**MINUTES OF 62<sup>ND</sup> MEETING OF EXPERT GROUP ON ZOO DESIGNING OF  
CENTRAL ZOO AUTHORITY**

**MONDAY, 13<sup>TH</sup> JULY, 2015**

##### **1. Revised design of proposed construction of Rescue Centre:**

APPROVAL DRAWING  
 SITE PLAN  
 SCALE: NTS, 30-05-2012  
 DWG NO : .....  
 REVISION : 03-07-2015.....

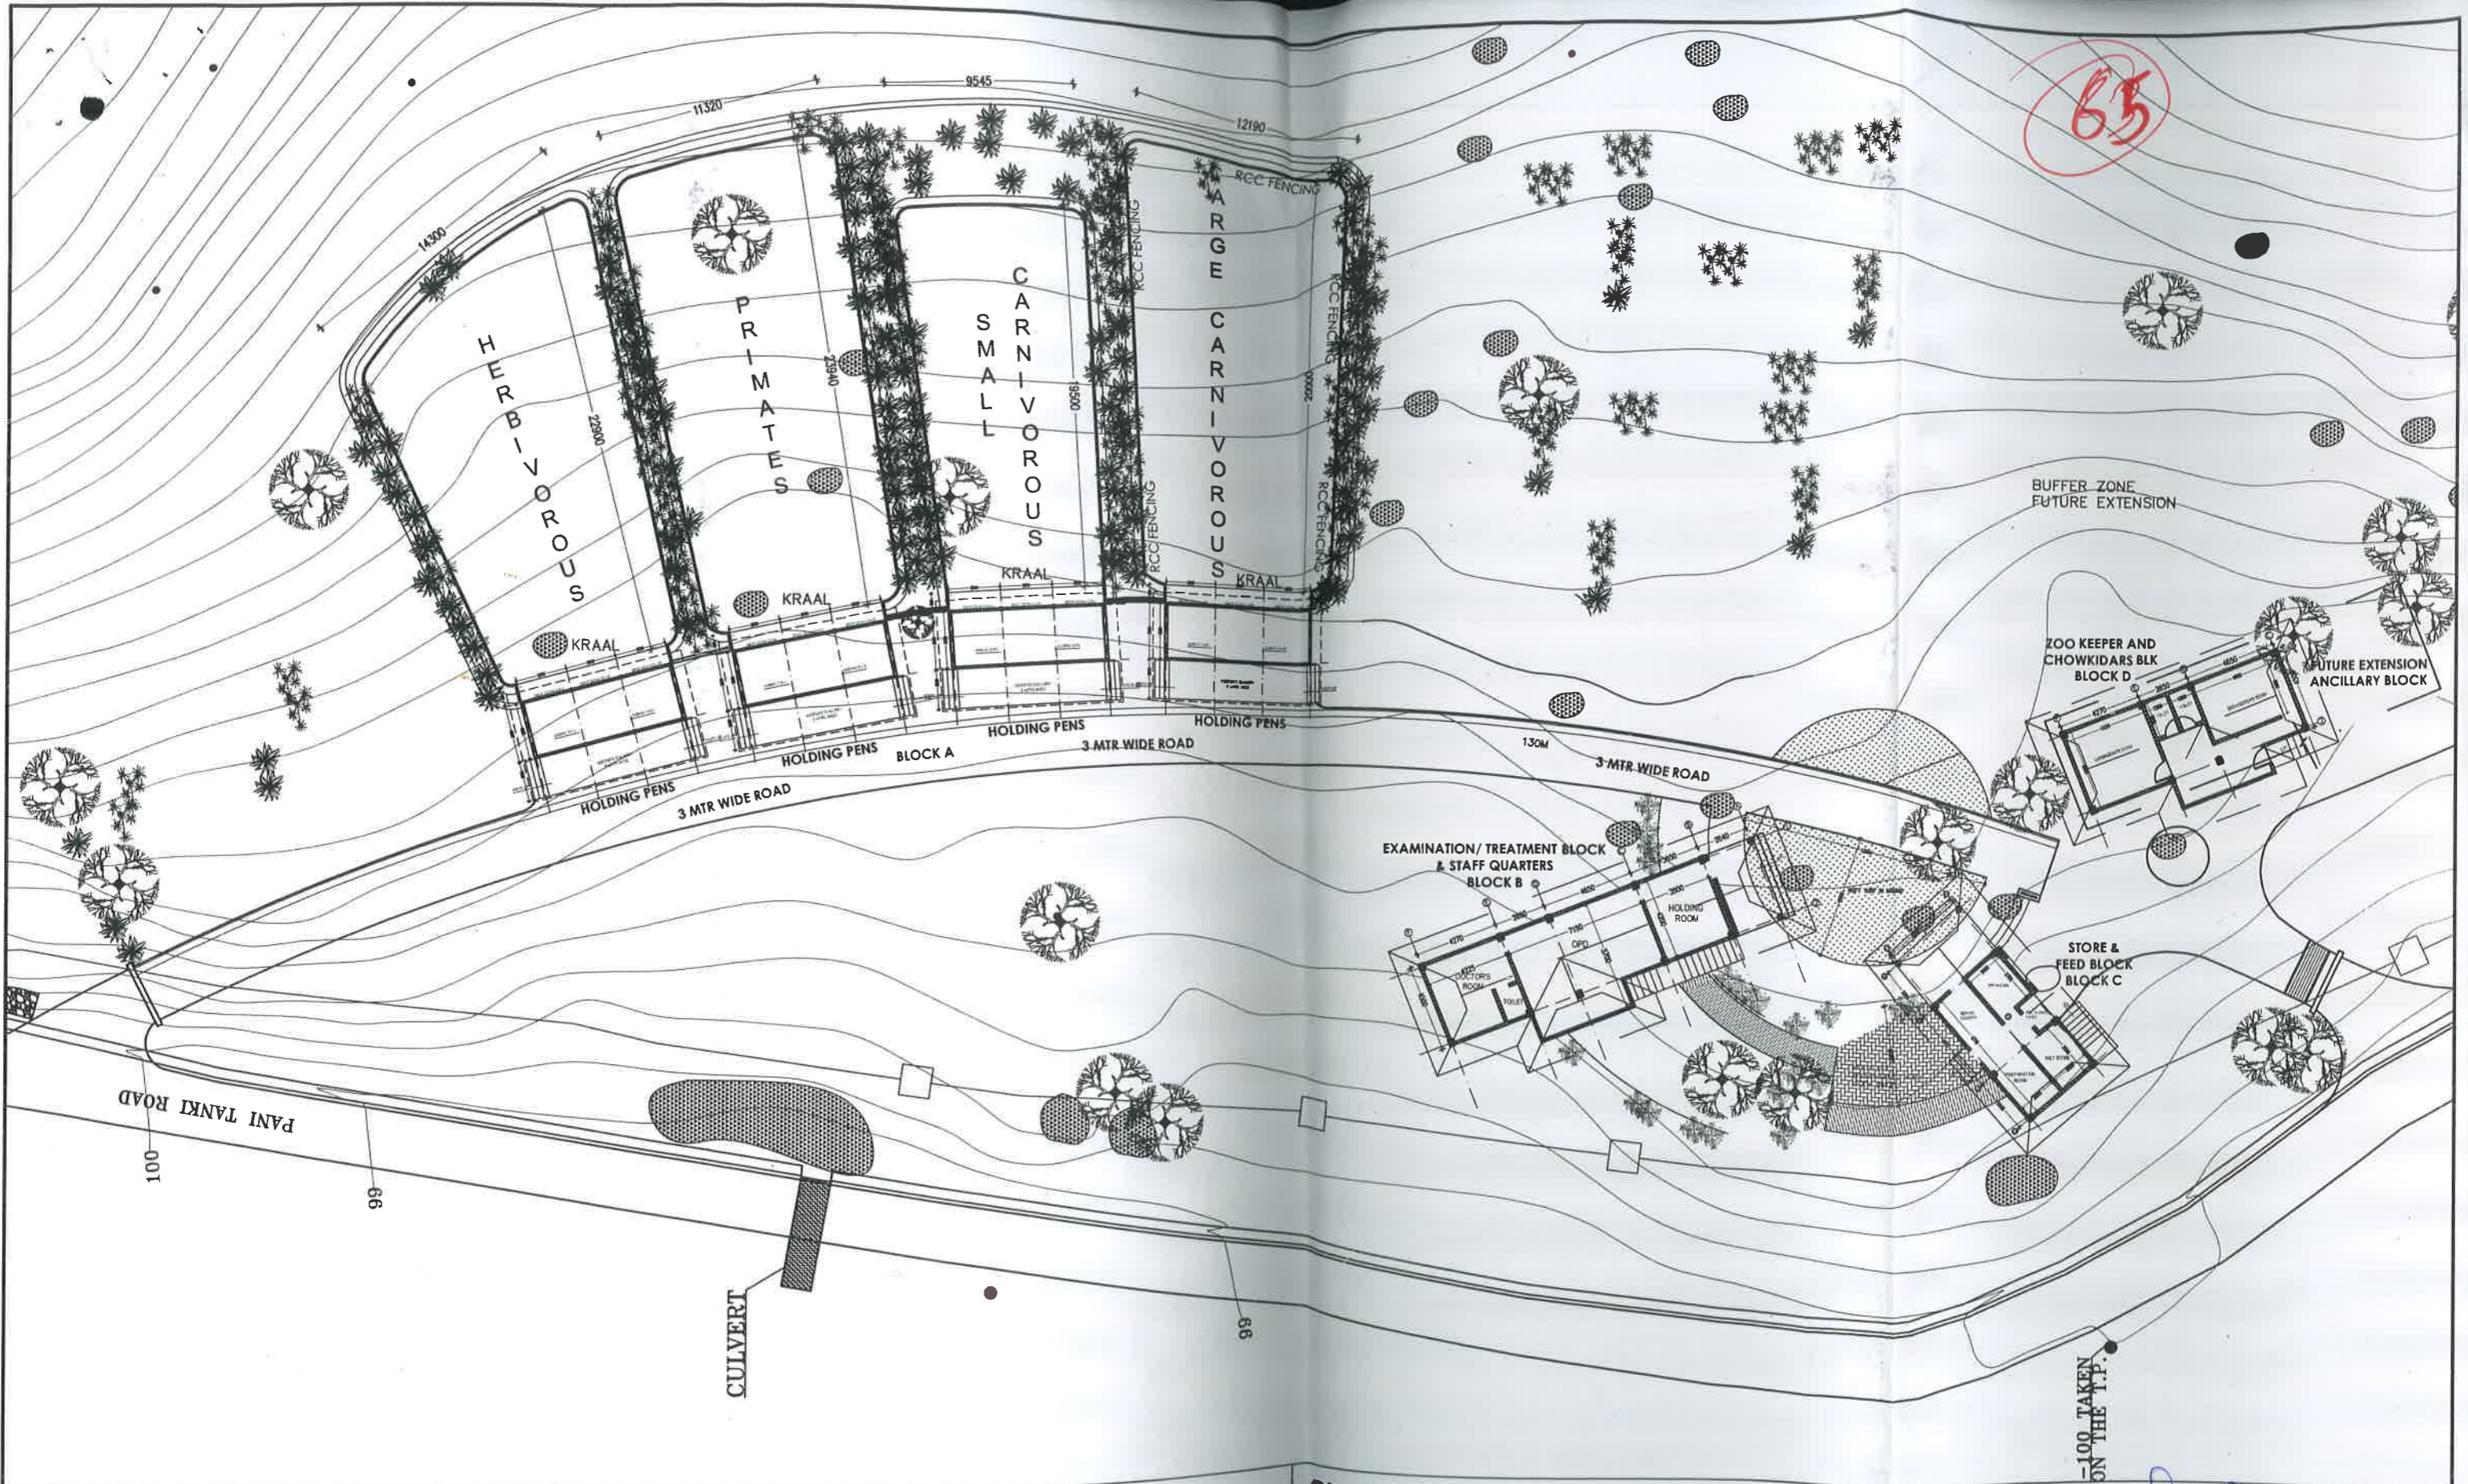
- a) Since there are chances of electrical failure due to reasons beyond control, it is advisable to use concertino wire also at the top of masonry wall besides providing hot wires, because the park adjoins Mahananda sanctuary.
- b) Elephant proof trench should also be shown in plan, elevation and section to remain in record of CZA.
